## ADDENDUM NO. 2

**Date:** June 15, 2015

**Project:** City of Tuscaloosa  
Rosewood Sanitary Sewer Improvements Project – Phase II  
Project No. A12-1617

**CONSTRUCTION EXIT PAD**  
N.T.S.

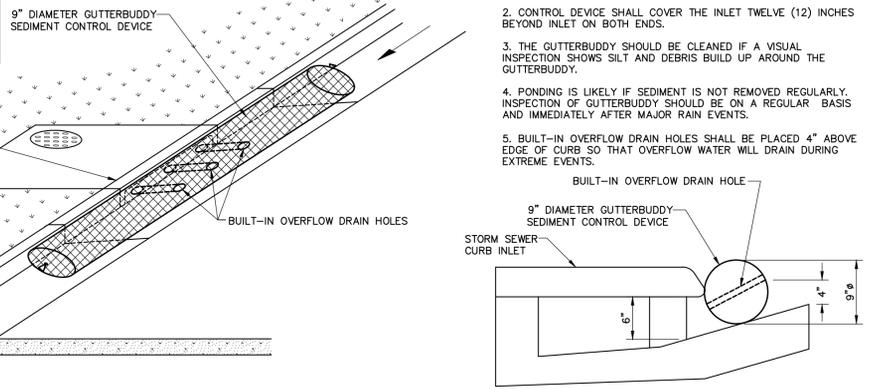
Construction Plan Sheet C3.0 has been revised to include a detail for the construction exit pad.

- WIDTH SHALL BE 25 FEET MINIMUM BUT MAY BE ADJUSTED TO EQUAL FULL WIDTH OF VEHICULAR EGRESS.
- A CLASS IV NON-WOVEN GEOTEXTILE MEETING THE REQUIREMENTS SHOWN IN TABLE CEP-1 OF THE ALABAMA HANDBOOK SHOULD BE USED UNDER RACK WHEN SUBGRADE IS SOFT & WILL NOT SUPPORT TRAFFIC WHEN WET.
- REMOVE LARGE CHUNKS OF MUD OR SOIL FROM EXIT PAD DAILY.
- TOP-DRESS WITH CLEAN STONE AS NEEDED TO MAINTAIN EFFECTIVENESS.
